ADDENDUM NO. 1

Additions & Renovations to Pleasant Run Elementary School
1800 North Franklin Road
Indianapolis, IN 46219

PROJECT: PLEASANT RUN ELEMENTARY SCHOOL RENOVATION & ADDITION

PROJECT NO: 2020061

4 UNIT B NORTH/SOUTH SCREEN
1/2" = 1'-0"

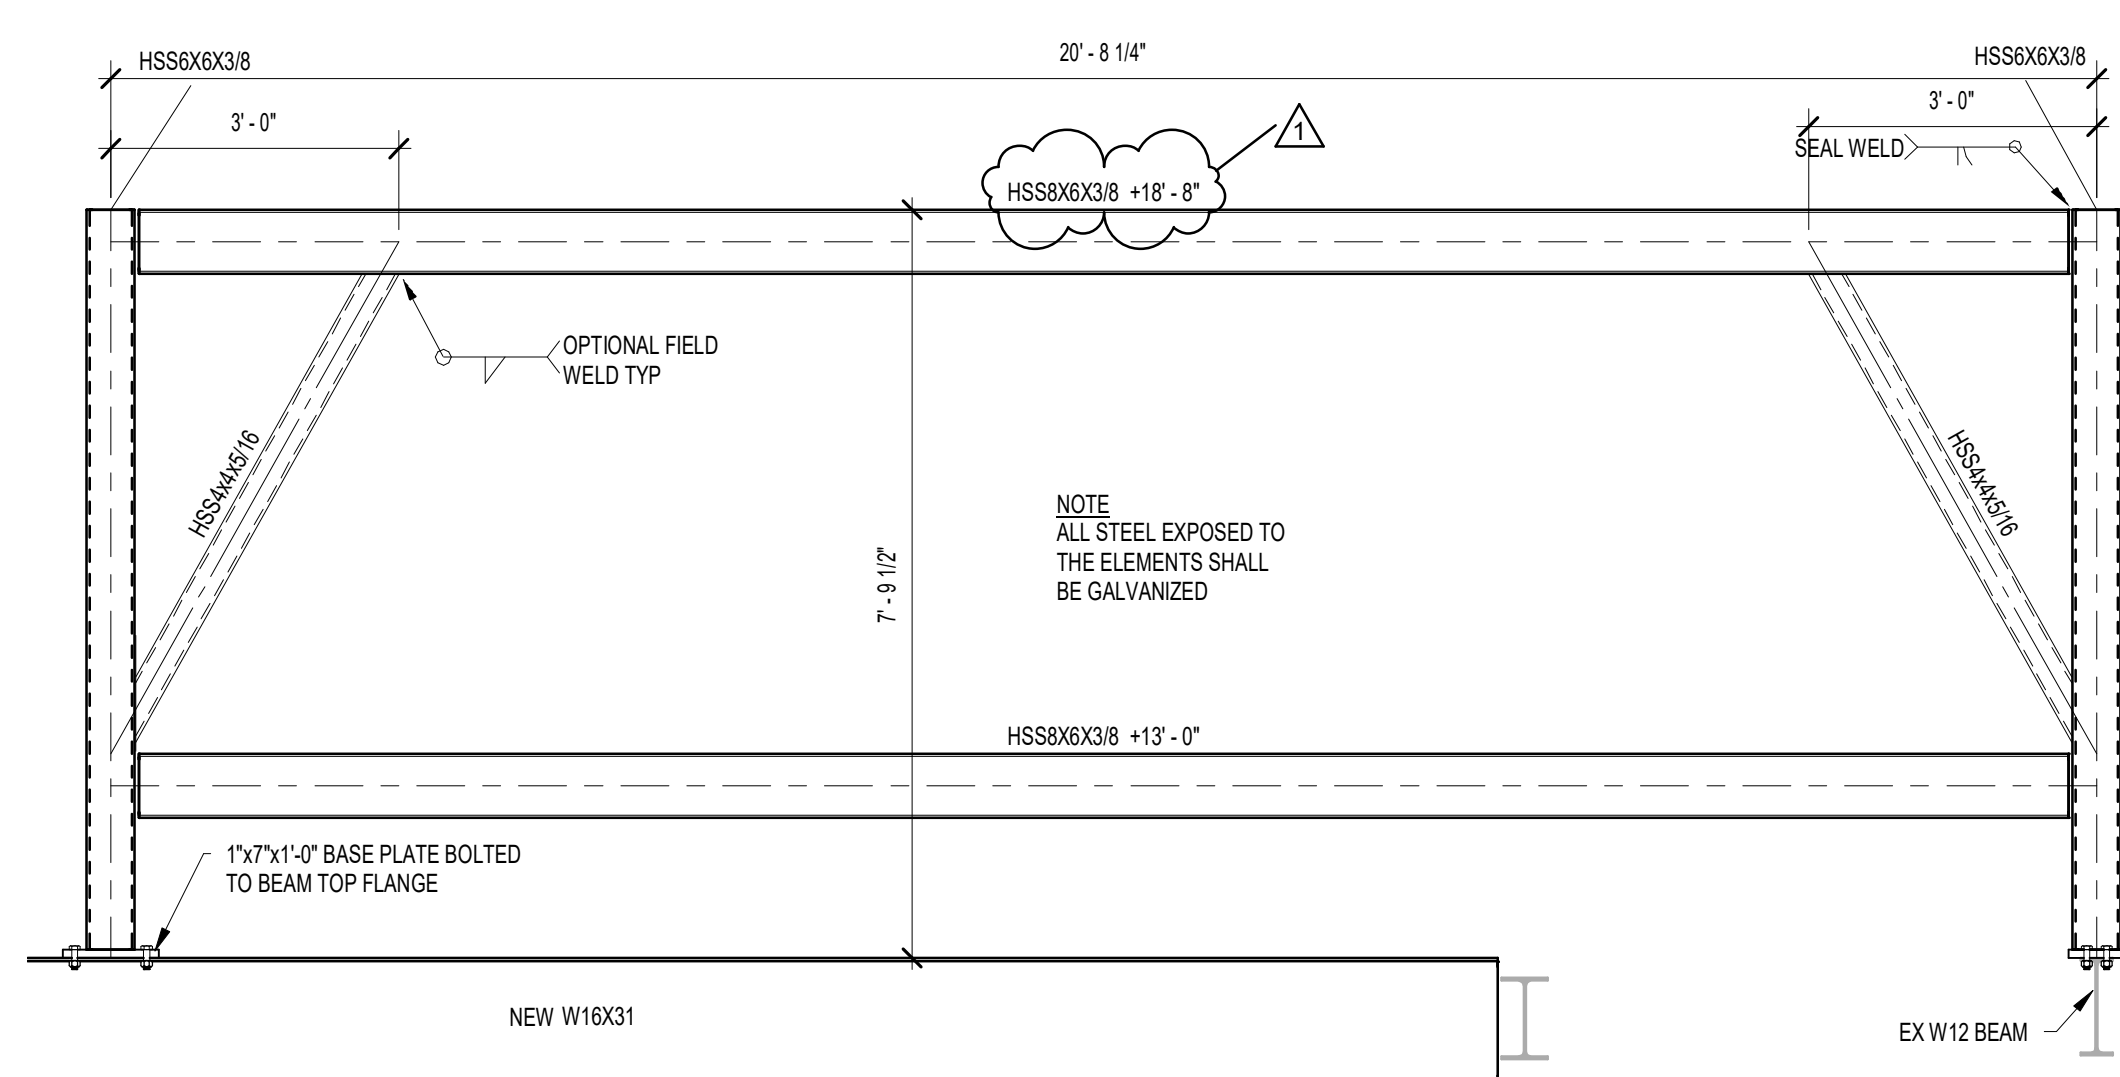
Drawing S301 Braced Frame Elevations

1. Show the modified dimensions and details of screen walls.

DRAWING NUMBER
S711

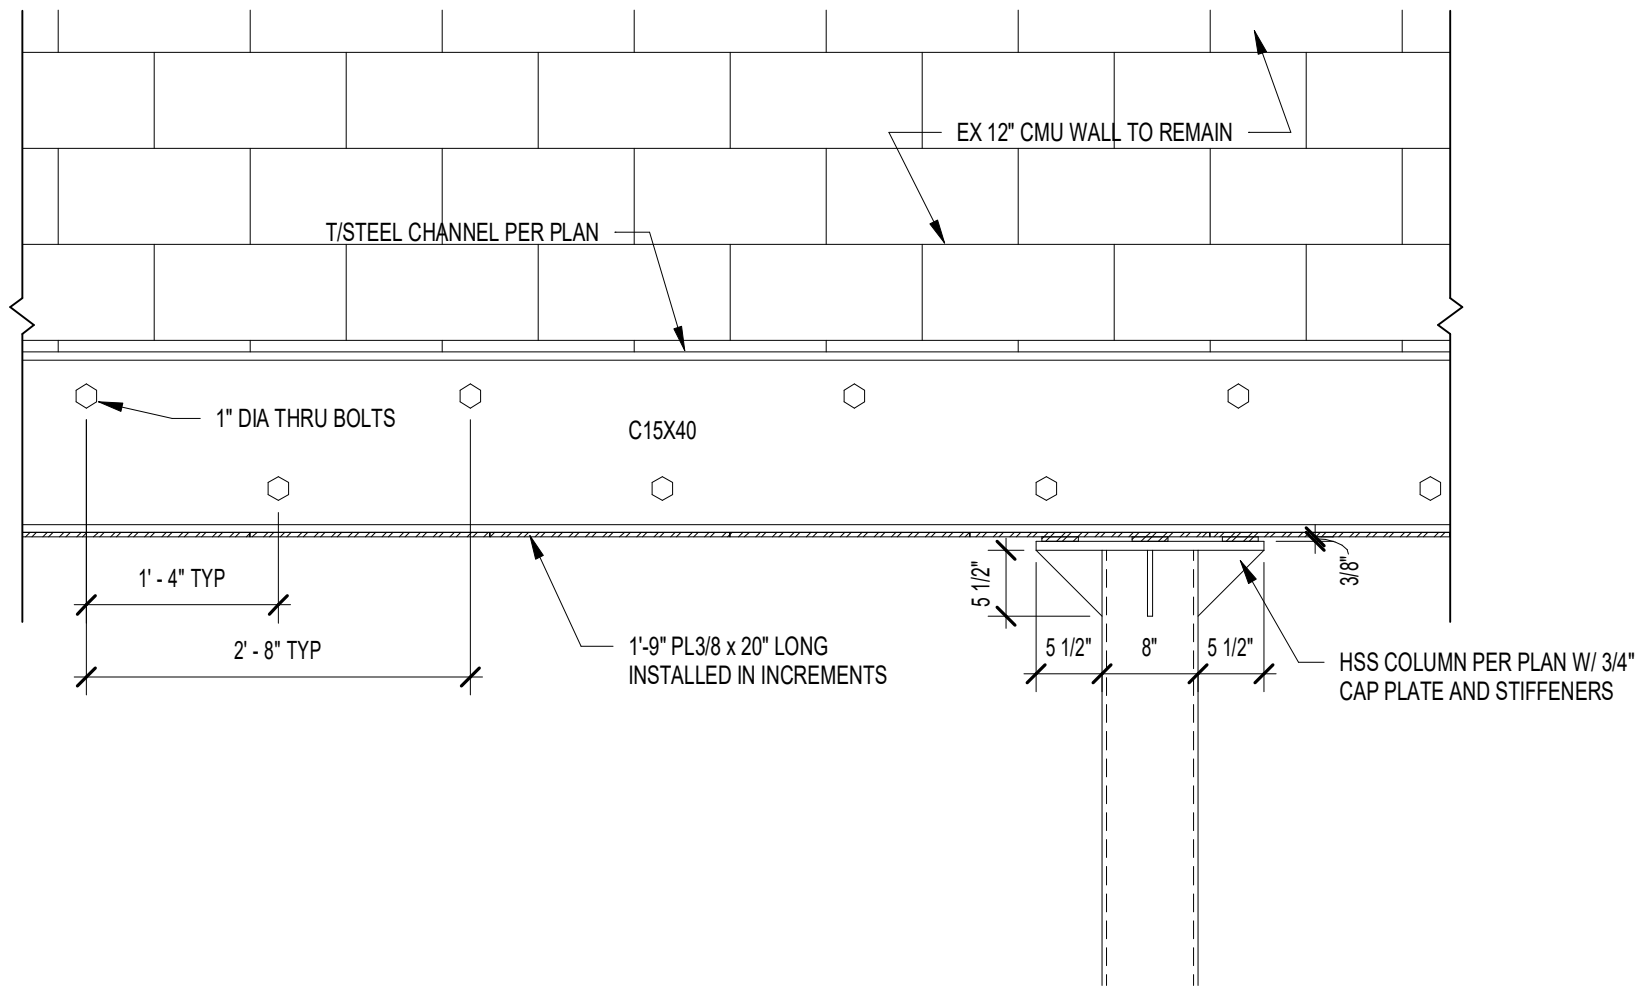
Drawing S711 Framing Sections and Details

1. 18/S711 shows WT4x12 framing in section.
2. 20/S711 shows the new T/S elevation of 2C15x40 wall support beam.

1 SECTION
3/4" = 1'-0"

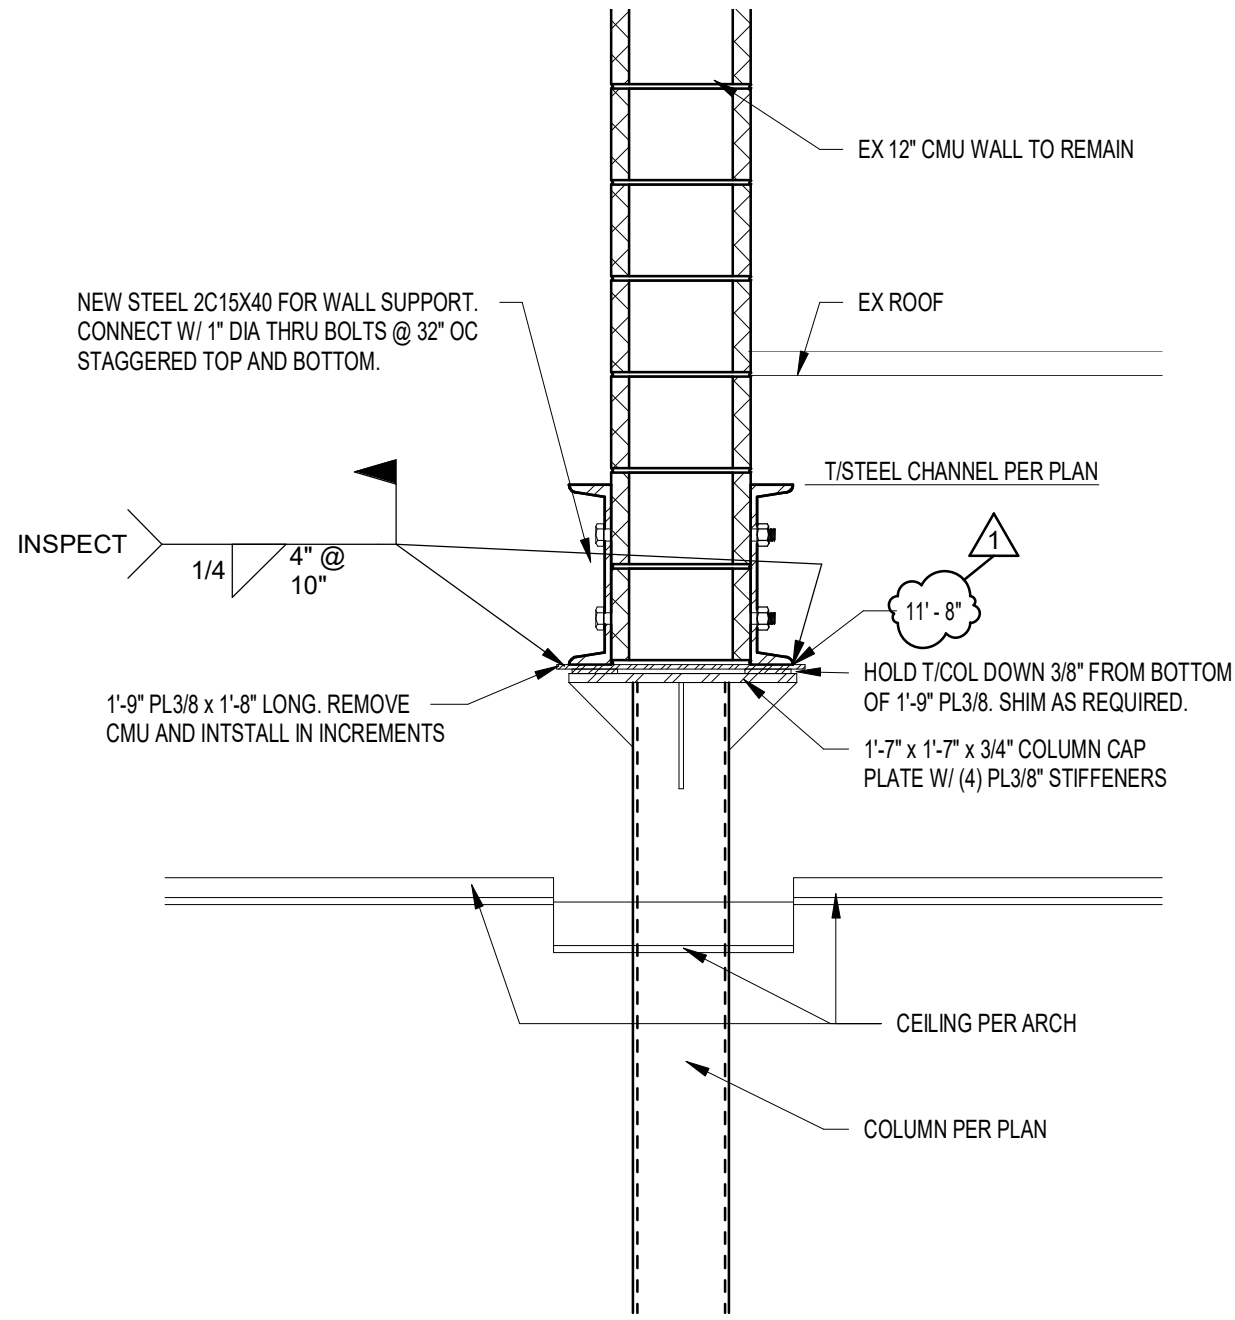
Drawing S712 Framing Sections and Details

1. 1/S712 shows the new T/S elevation of 2C15x40 wall support beam.
